**SAN ANTONIO WATER SYSTEM
Sawyer Meadows 18" Oversize
Solicitation No. B-13-050-CM
SAWS Job No. 12-1622**

ADDENDUM NO. 1

July 12, 2013

| SHEET | C4.00 |

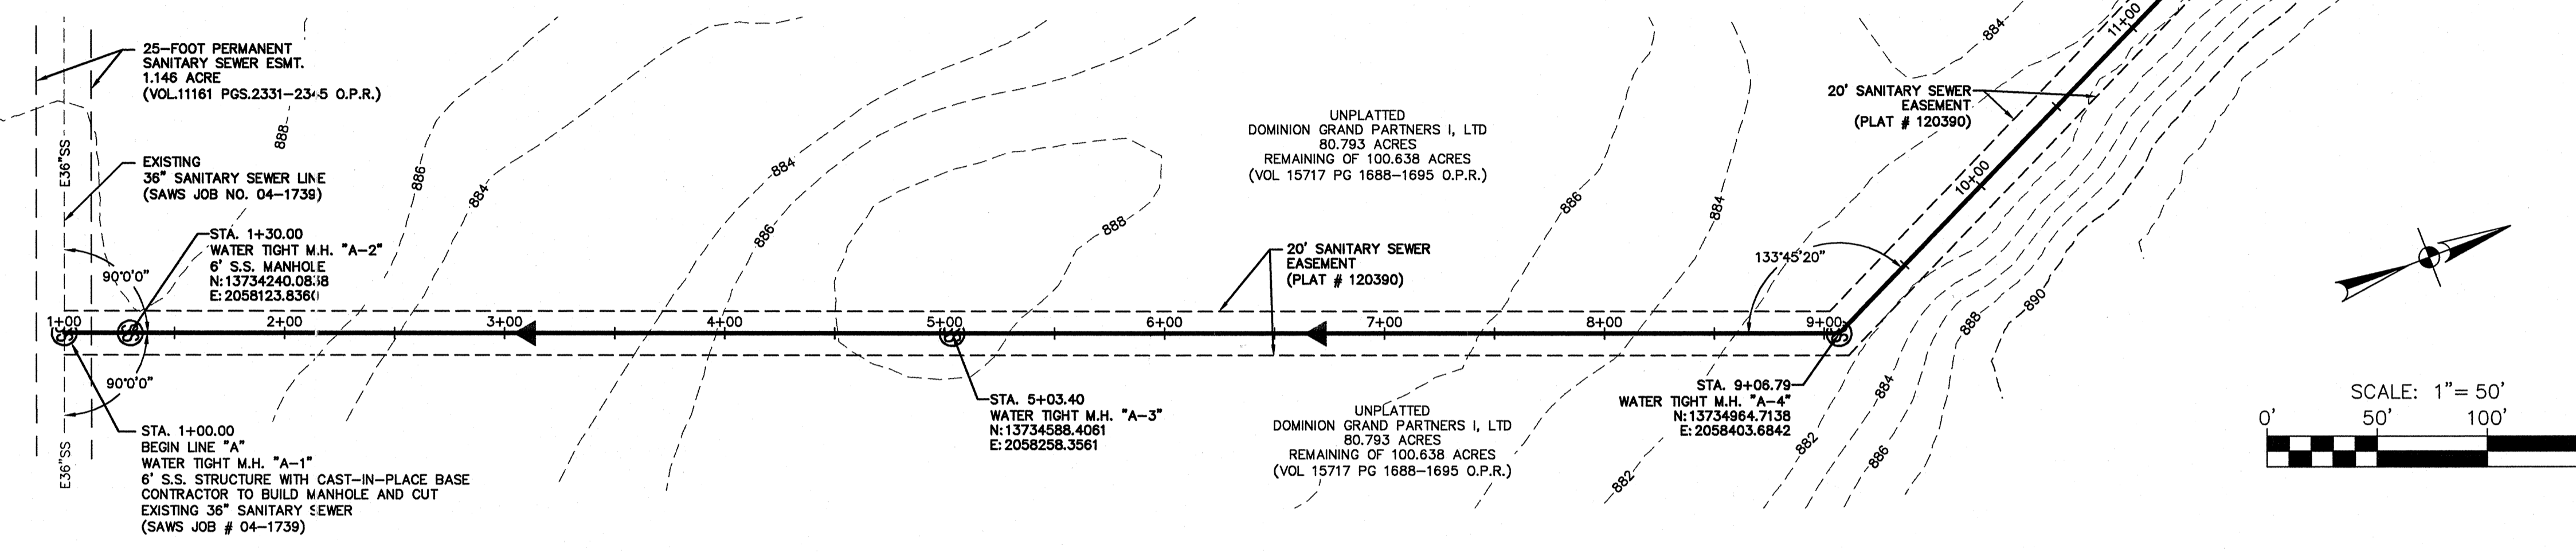
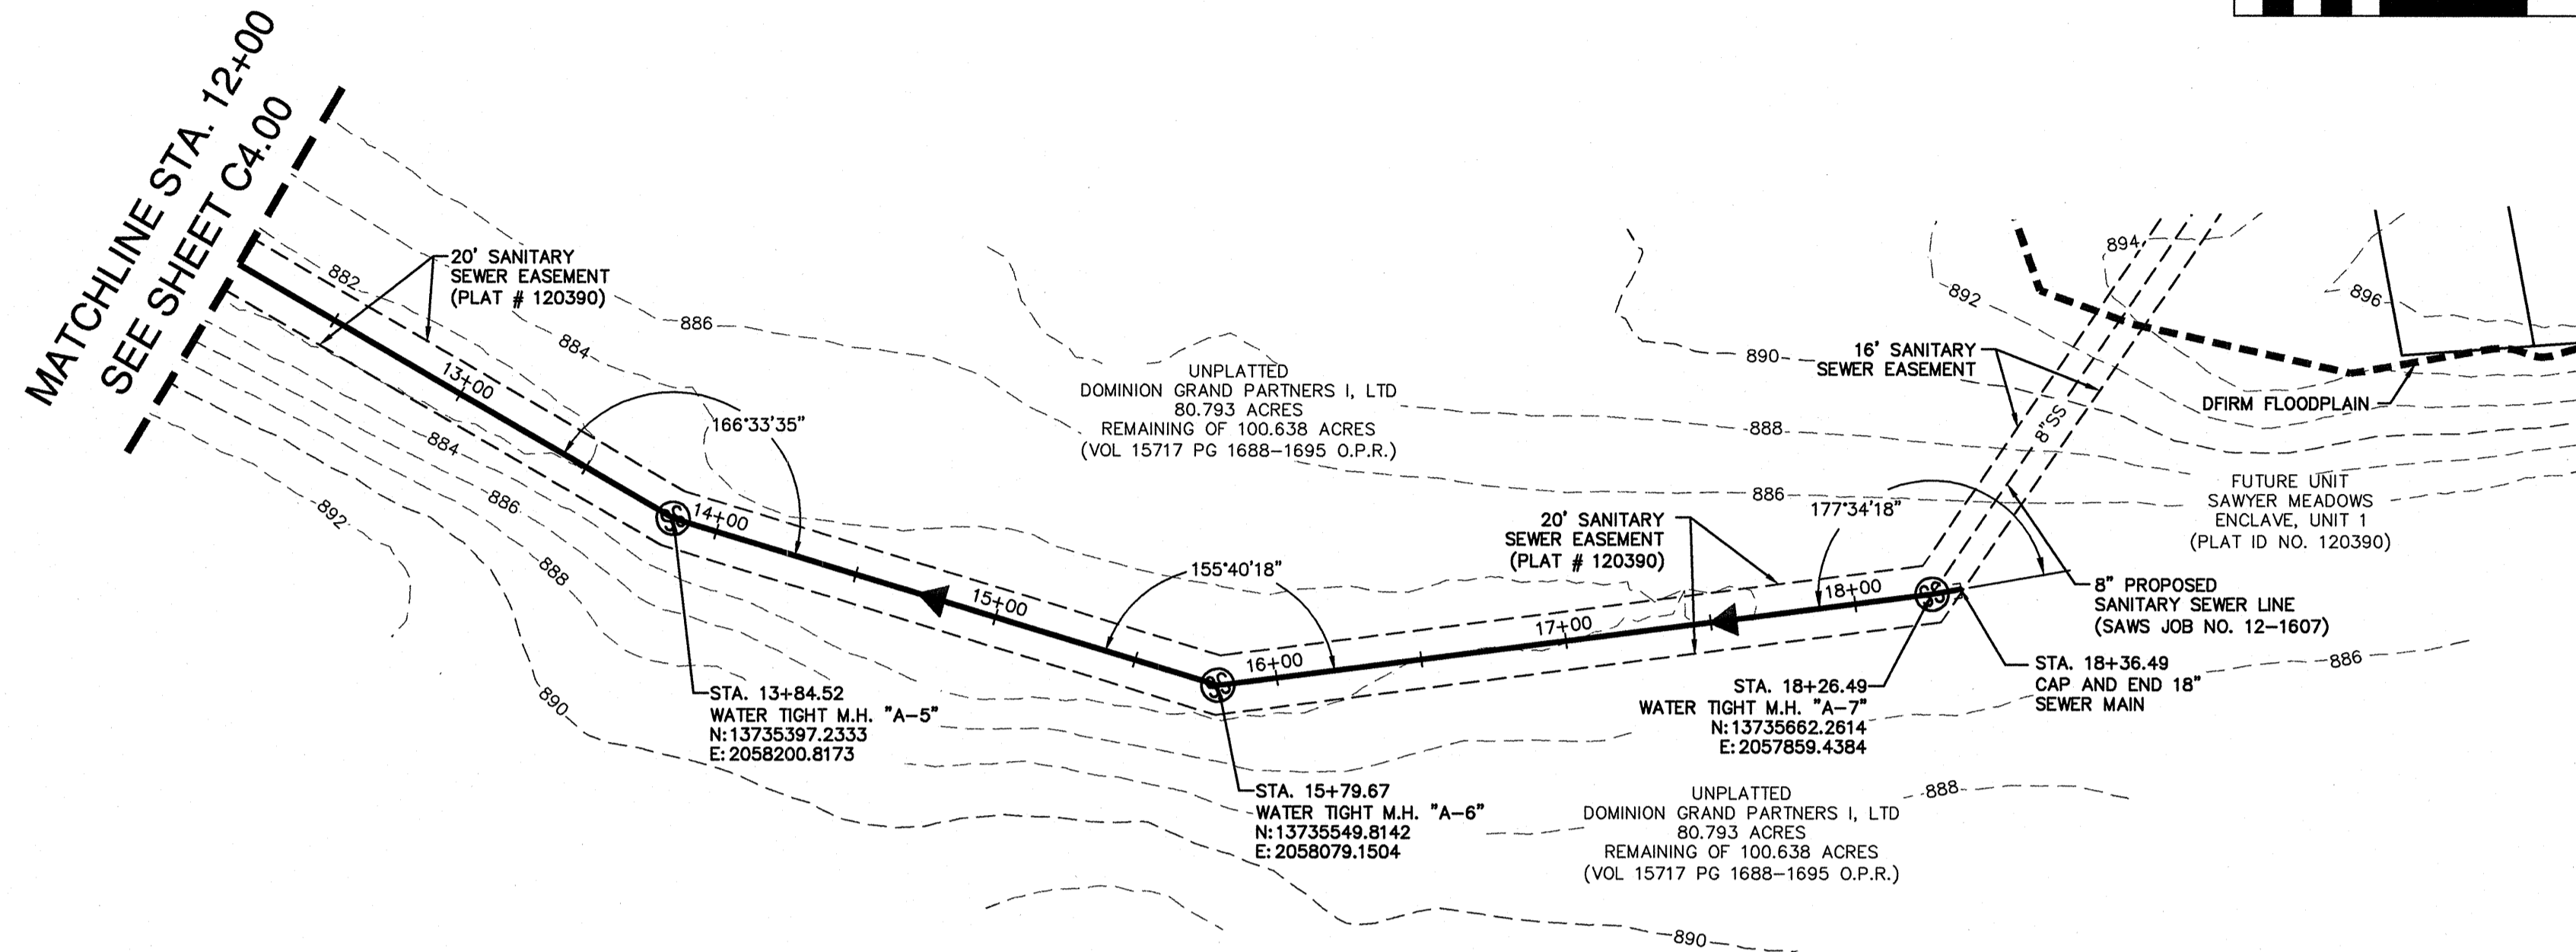
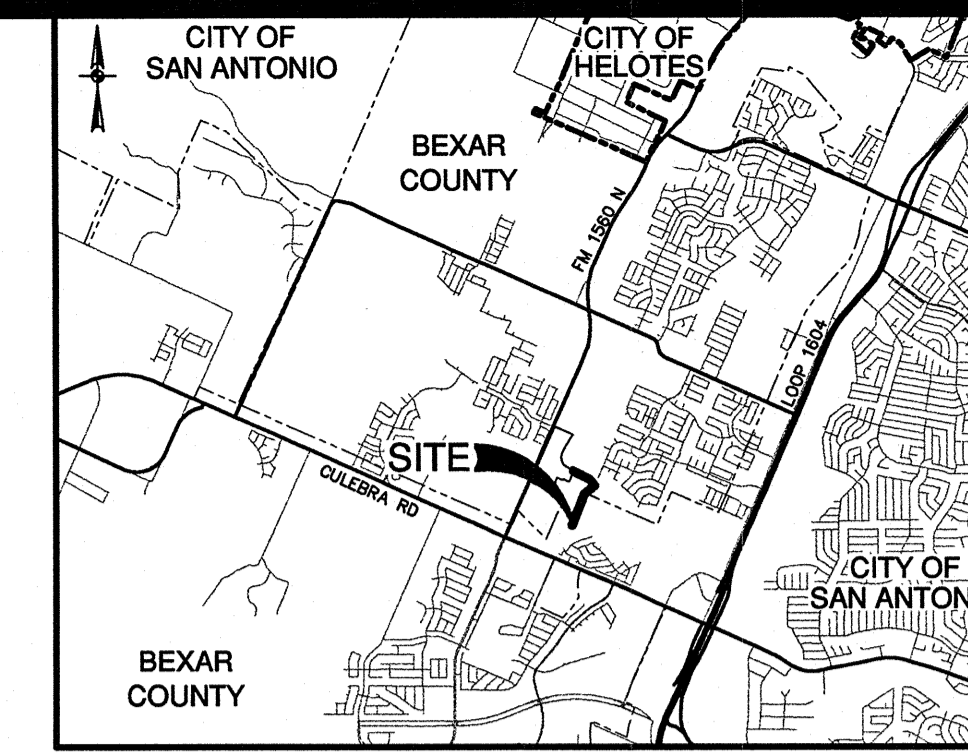
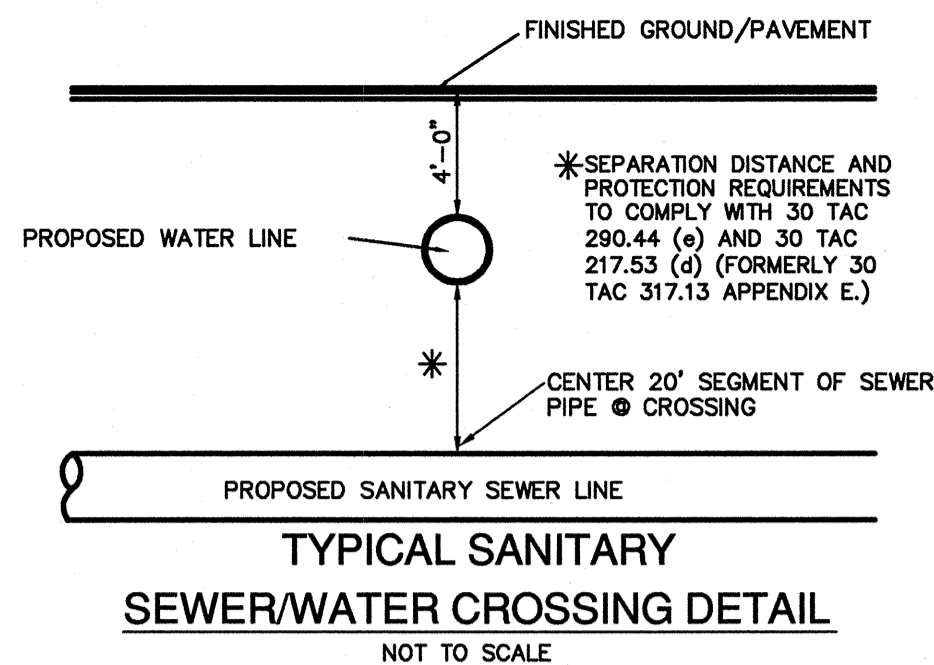
- A. The Engineer's Estimate of project cost for the above mentioned project has been revised to \$ 494,371.37.
- B. Tie to Existing Sewer Main Item 852 was removed as a quantity line item from the plans and the bid proposal.
- C. Revised Bid Proposal (See attached).
- D. Revised Plan Sheets C4.00 and C4.01 (See attached).

| NO. | REVISION | DATE |
|-----|------------------------------|---------|
| 1. | REVISED NOTES AND QUANTITIES | 7/12/13 |

6. CONTRACTOR TO PLACE FLOWABLE FILL FROM TOP OF CONCRETE ENCASUREMENT OVER PIPE TO LIMITS OF ROCK CUT IN TRENCH. CONTRACTOR TO PLACE SECONDARY BACKFILL FROM LIMITS OF ROCK CUT TO SAW CUT LINE.

PLAT NO. _____
 JOB NO. 7974-02
 DATE FEBRUARY 2013
 DESIGNER DL
 CHECKED SL DRAWN SL
 SHEET C4.01

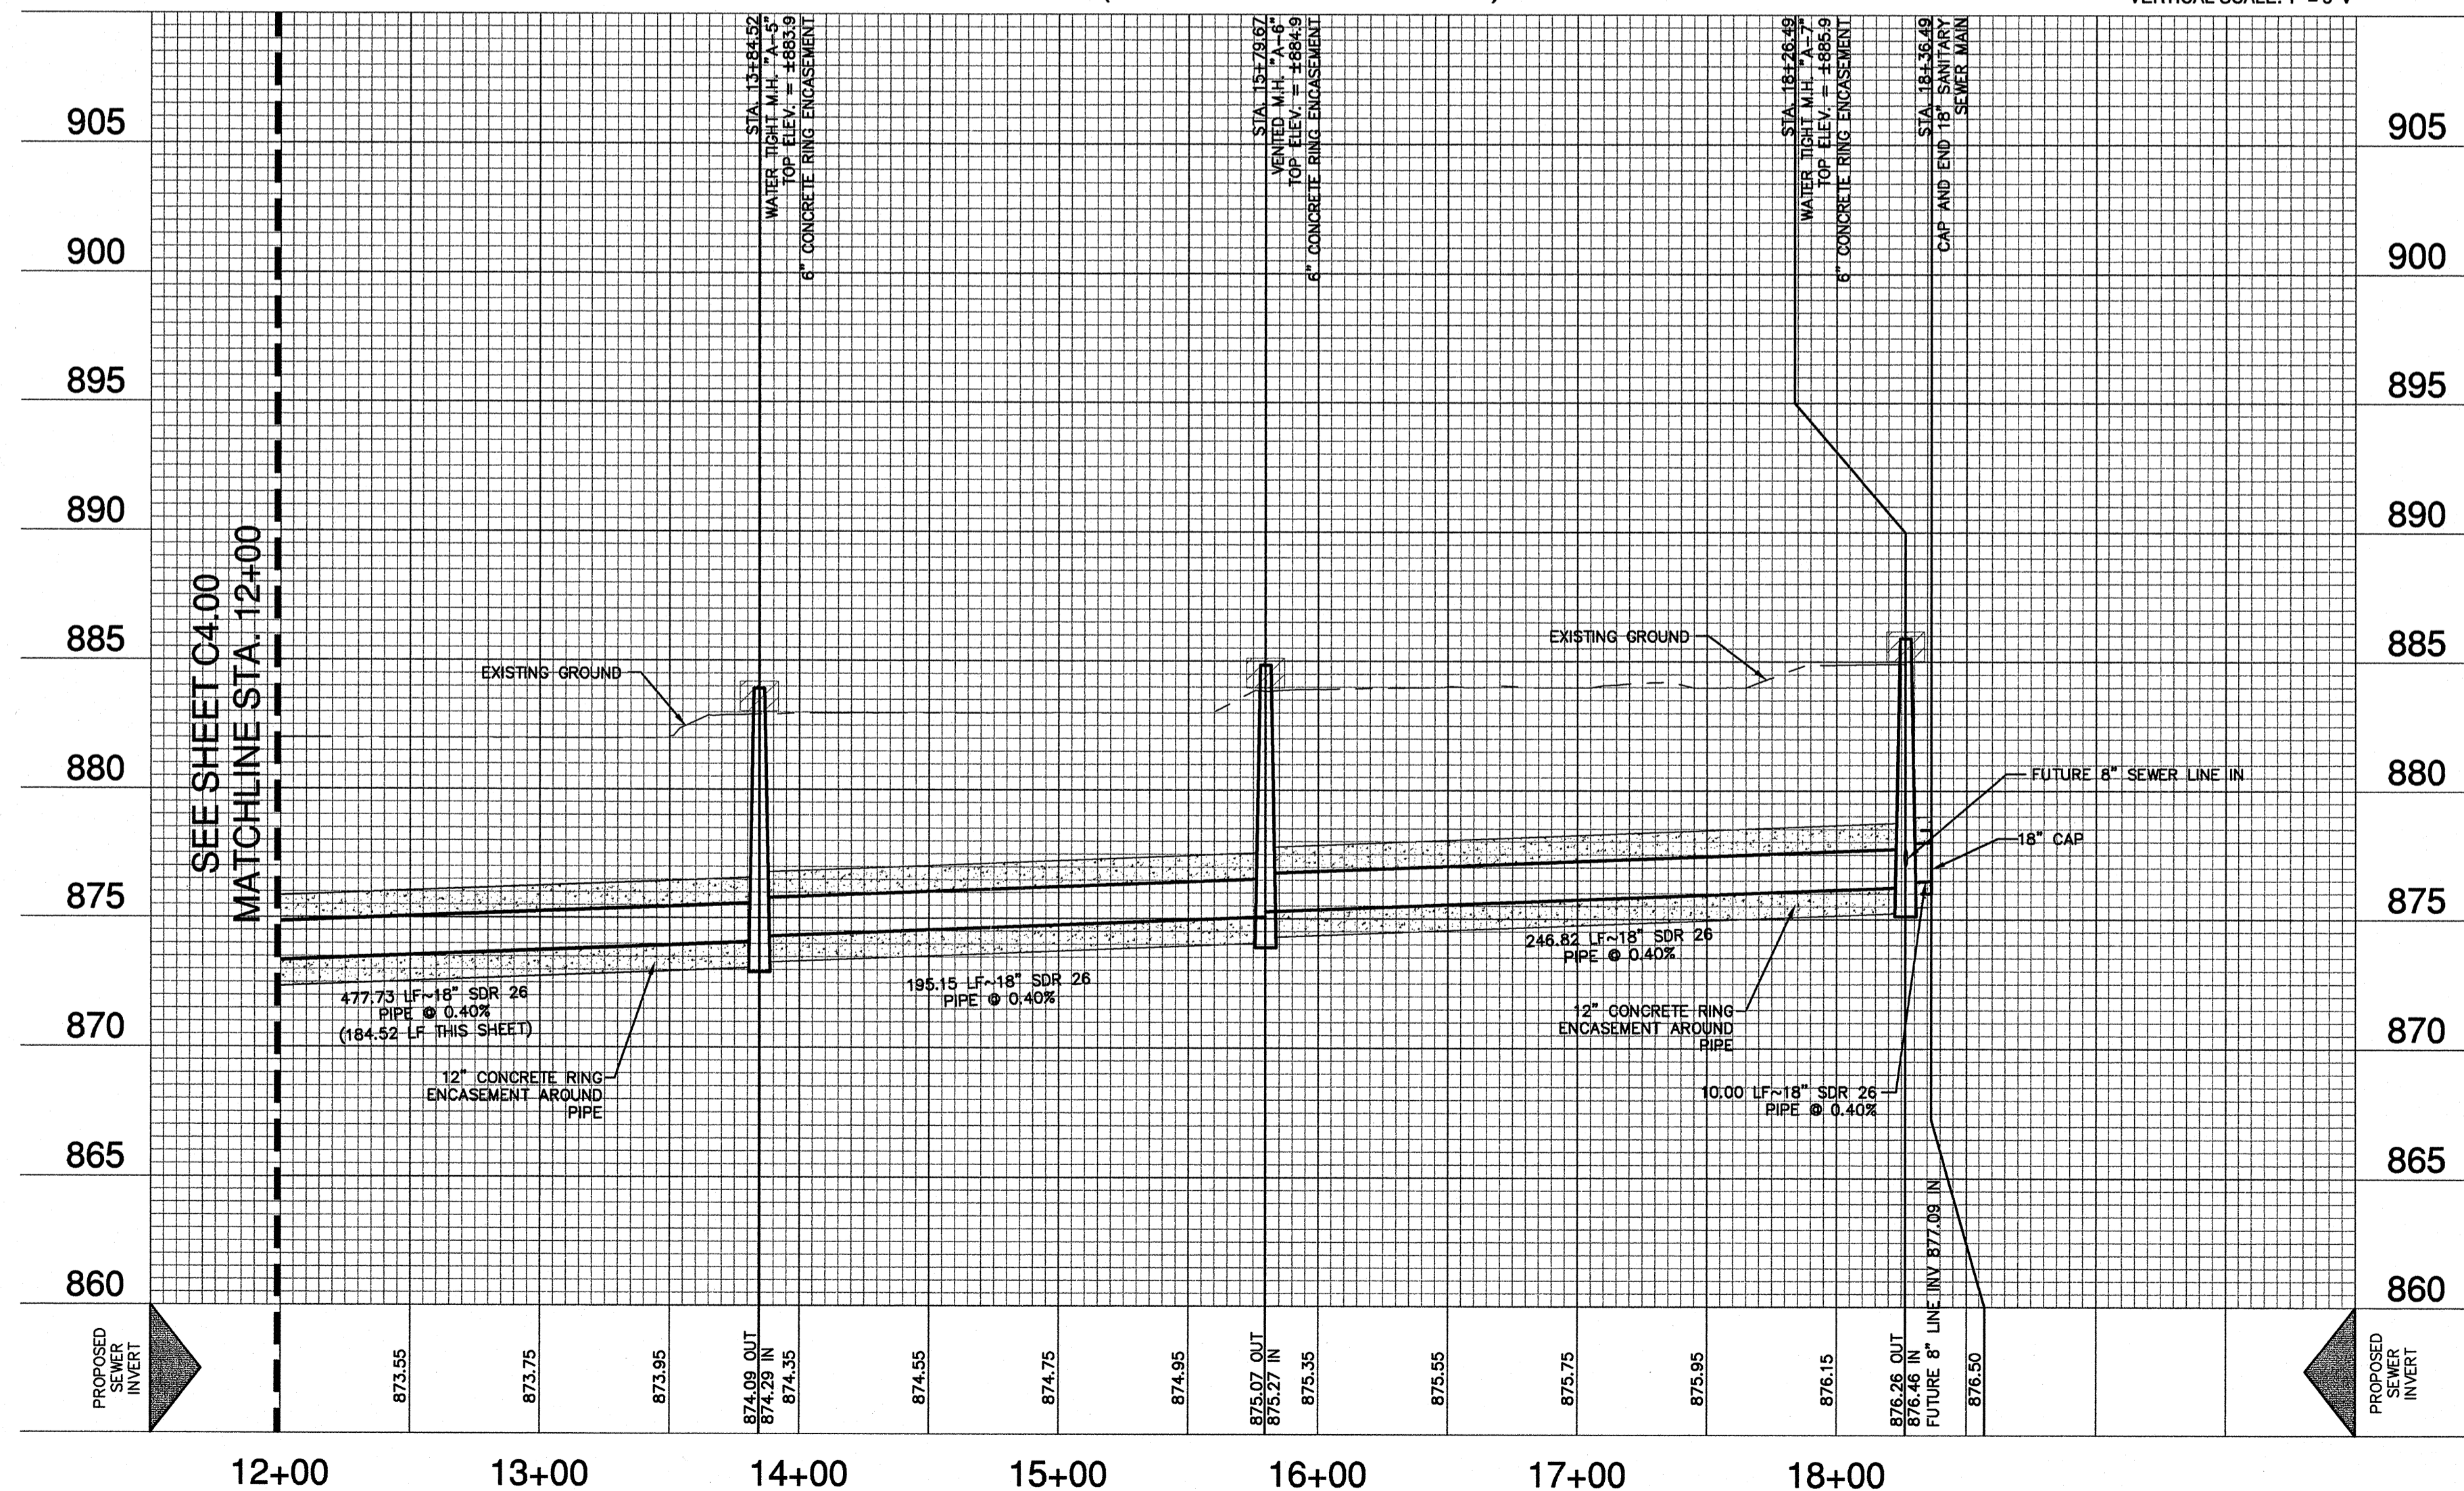
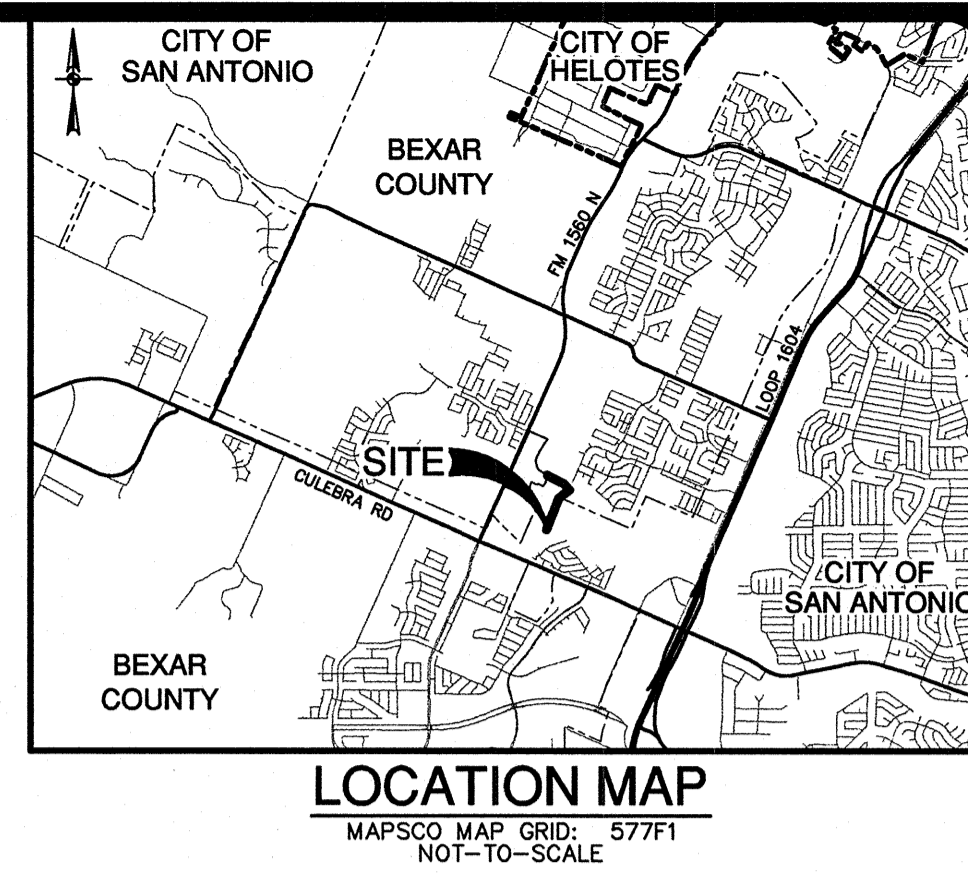
6. CONTRACTOR TO PLACE FLOWABLE FILL FROM TOP OF CONCRETE ENCASUREMENT OVER PIPE TO LIMITS OF ROCK CUT IN TRENCH. CONTRACTOR TO PLACE SECONDARY BACKFILL FROM LIMITS OF ROCK CUT TO SAW CUT LINE.

NO. REVISION
 1. REVISED NOTES AND QUANTITIES 7/12/13
